**Planning Permit Application: TP-2014-41  
35 and 37 Barnett Street, Kensington**

10 February 2015

1. The purpose of this report is to advise the Future Melbourne Committee of an application for planning permit TP-2014-41 at 35 and 37 Barnett Street, Kensington (refer Attachment 2 – Locality Plan).

2. The application seeks approval to demolish the existing buildings and construct a part two/part three storey residential building comprising five townhouses, a new vehicle crossover and a reduction in the standard car parking requirements (refer Attachment 3 – Plans).

**TP.02**

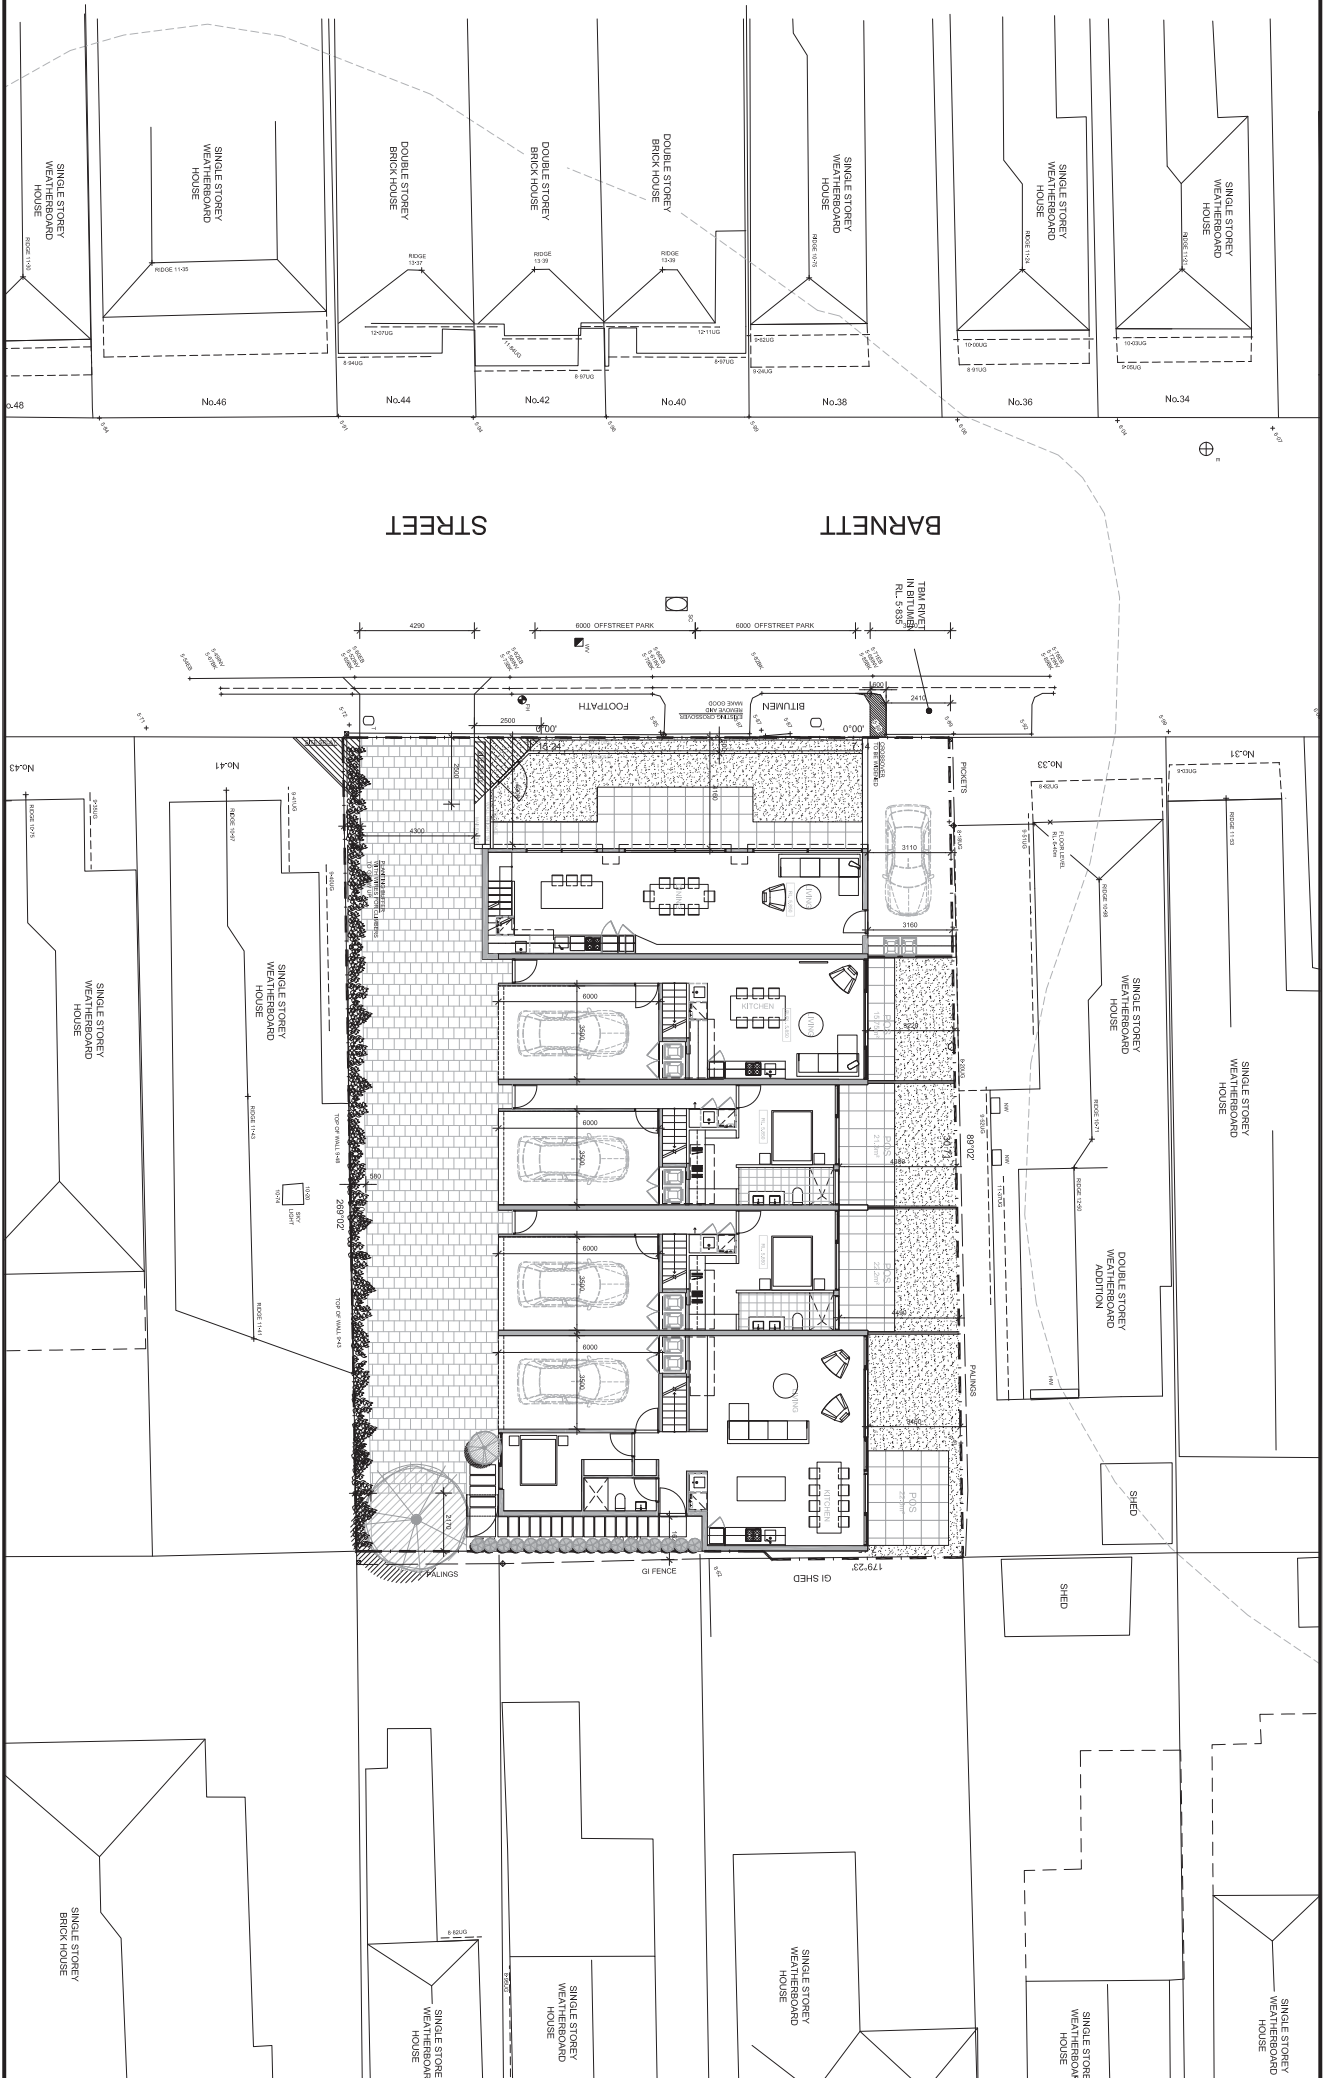
- The building setback is shown as 2.83m from the main western elevation (Refer to drawing TP.02). We are of the opinion that an extended building setback of 4m would be more successful in mediating the additional building height relative to the adjacent residential properties to the immediate north and south. This change would also have the added benefit of increasing the area of deep soil zone at the property edge fronting Barnett Street.

The building is setback (of 4.0 metres) is supported and mediates the additional building height relative to the adjacent residential properties to the immediate north and south. This change would also have the added benefit of increasing the area of deep soil zone at the property edge fronting Barnett Street.

- The front wall of the development is setback approximately 4.0 metres from Barnett Street. The setback mediates the additional building height relative to the adjacent residential properties to the immediate north and south (i.e. the front of the veranda at 33 Barnett Street is setback 1.6 metres from the street and the front wall of the dwelling at 41 Barnett Street is setback 2.5 metres from the street). This setback directly responds to the concern raised by the heritage advisor.

WEST ELEVATION

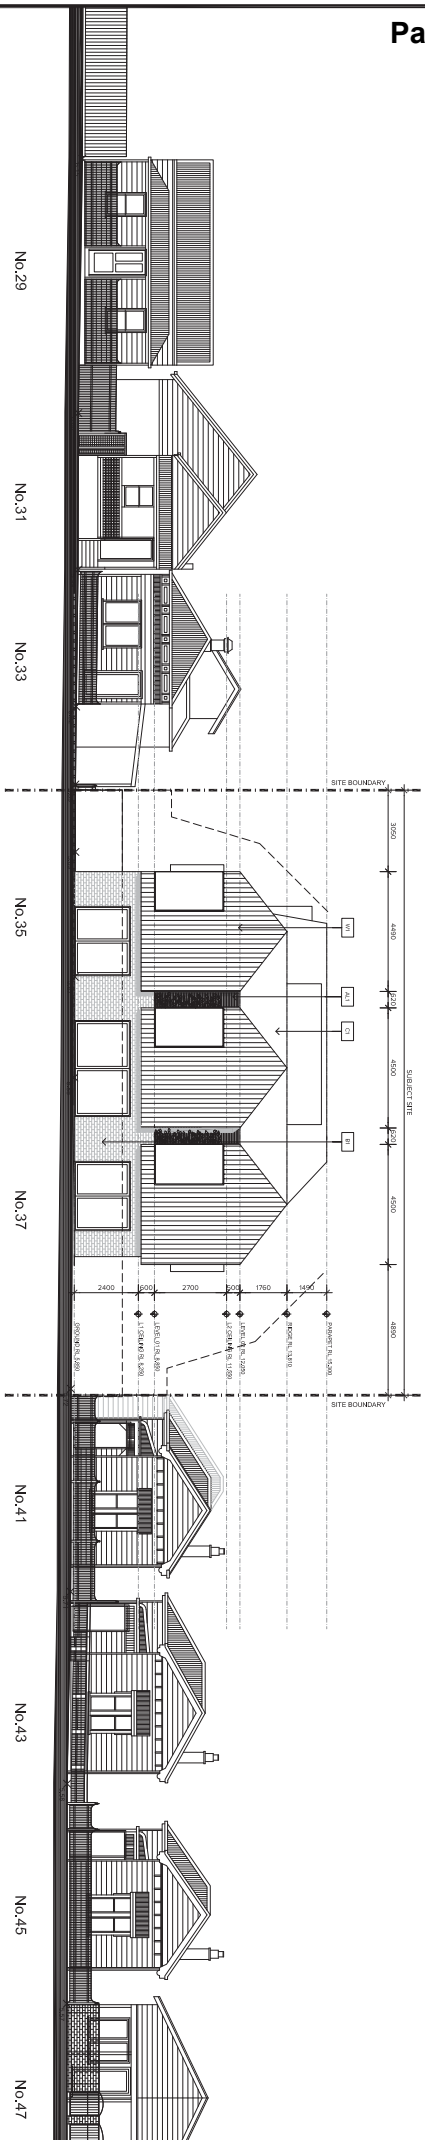
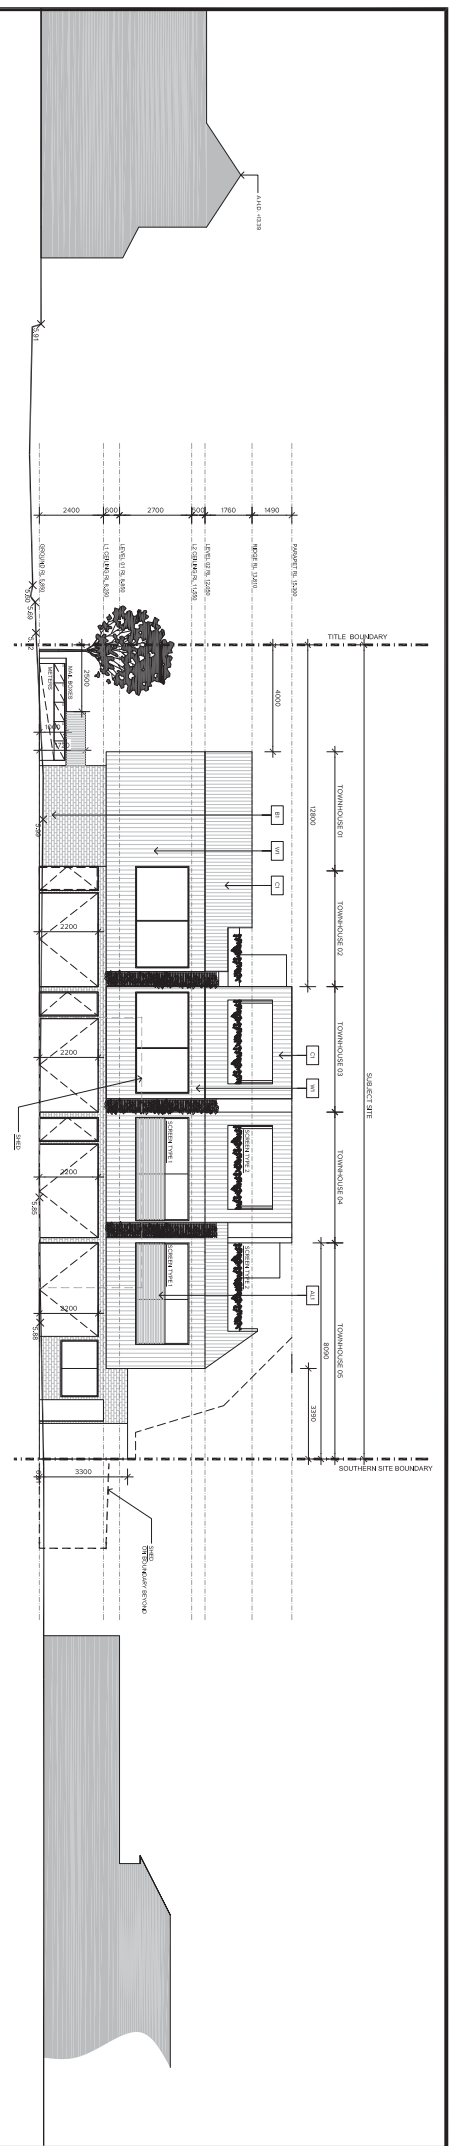
- Whilst it is understood that the intent is to reduce building bulk through the articulation of mass, we note that the front western elevation does not fully illustrate the entire extent of the building height. We therefore recommend that all building elevations be updated to clearly show all building edges and heights.

The development has a front and rear section. I note that on the Street (west) elevation on TP.06, the rear section is delineated in grey and is effectively not shown on the drawing; and that on sheet TP.07, the south elevation is similarly not shown on the (rear) east elevation.

FIGURE 3: STREETScape ELEVATION

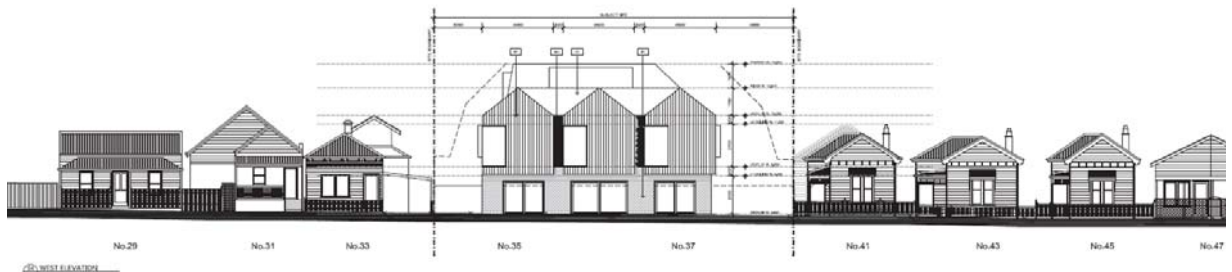
- Although the two storey built form (fronting Barnett Street) will be higher than many of the single fronted dwellings further to the south of the site, the juxtaposition of double and single storey dwellings is not atypical in the proposed heritage area and it is a site condition which exists in the immediate context of this site. The transition in height between the proposed development and the adjoining dwellings is therefore considered to be appropriate (refer to Figure 3 below) and is considered respect the low scale nature of the surrounding area.

- The second floor level is setback approximately 8.8 metres behind the front wall of the development, or 12.8 metres from the frontage. Whilst the second floor level will be visible at an oblique angle from the street (by virtue of the generous side setbacks), it will be very recessive and maintain the appearance of two storey development to the street. This responds to the particular concern regarding the height of the building raised by the heritage advisor.
